केन्द्रीय चिड़ियाघर प्राधिकरण  
**Central Zoo Authority**

**F. No. 19-15/92-CZA(128)(Vol.V)(M)**

**Sub:- Development of Sri Chamarajendra Zoological Gardens, Mysore.**

The proposed designs for the construction of animal enclosures at the Sri Chamarajendra Zoological Gardens, Mysore were placed before the 5<sup>th</sup> Meeting of the Expert Group on Zoo Designing held on 15<sup>th</sup> July, 2008 and the following observations are being made:—

TITLE:  
PROPOSED LAYOUT PLAN SHOWING THE POSITIONING OF SNAKE CAGES IN CHAMARAJENDRA ZOO, IN MYSORE

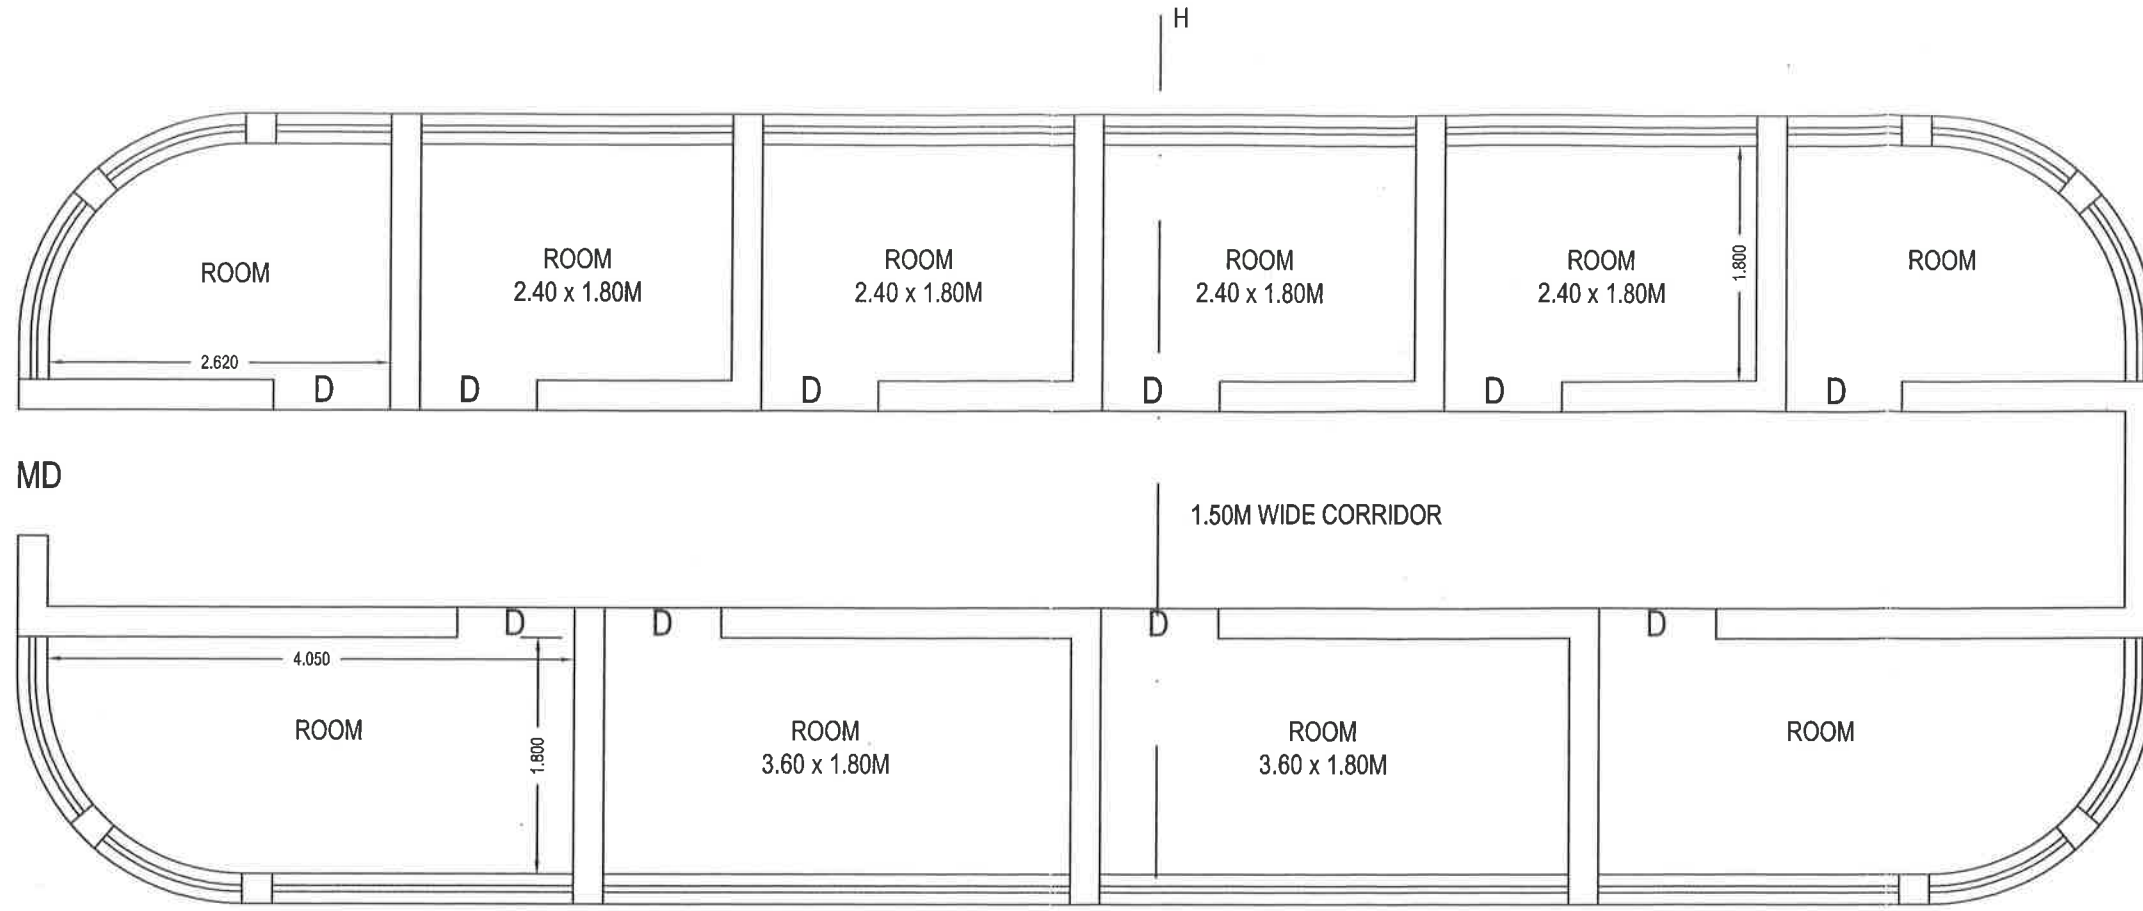
**(iii) Proposed construction of Snake enclosures**

CONSTRUCTION OF CAGE FOR COBRA, VIPER, KRAIT, TRINKET, SANDBOA AND GREEN VIPER SNAKES IN SRI CHAMARAJENDRA ZOOLOGICAL GARDEN, MYSORE

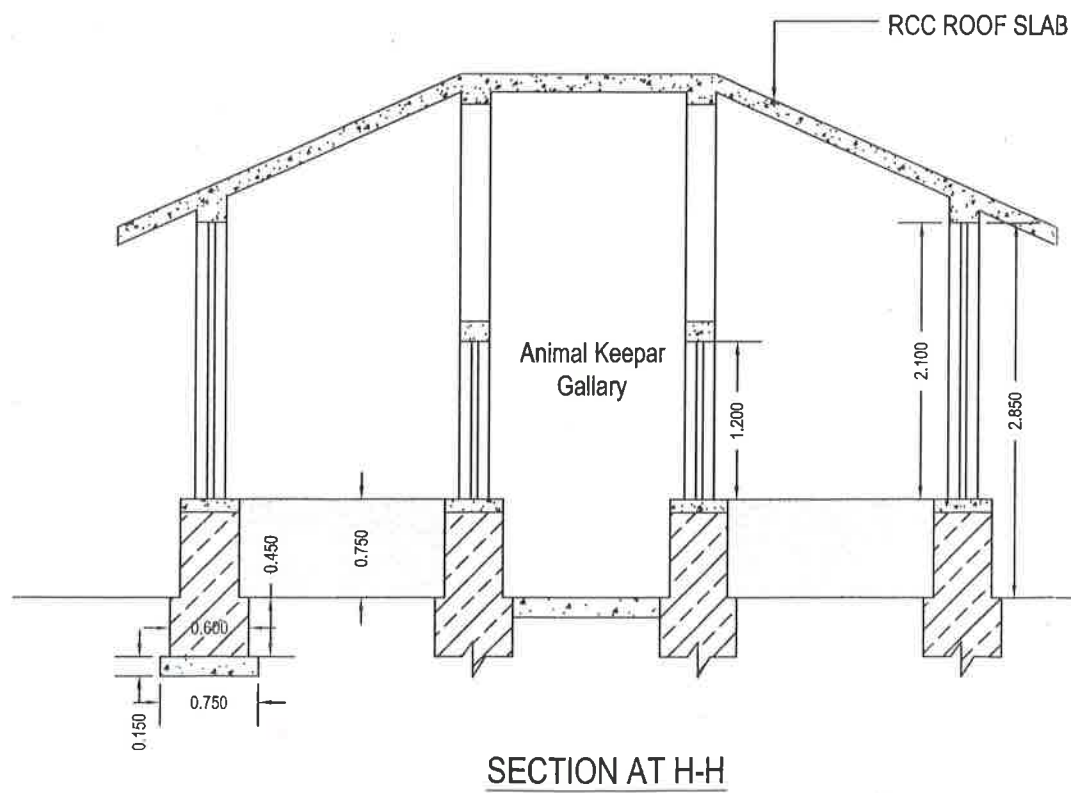
**(d) Cobra Viper, Krait, Trinket, Sandboa and Green Viper**

The designs were approved subject to that the Zoo Operator should provide six cubicles/ house instead of 10 as proposed.
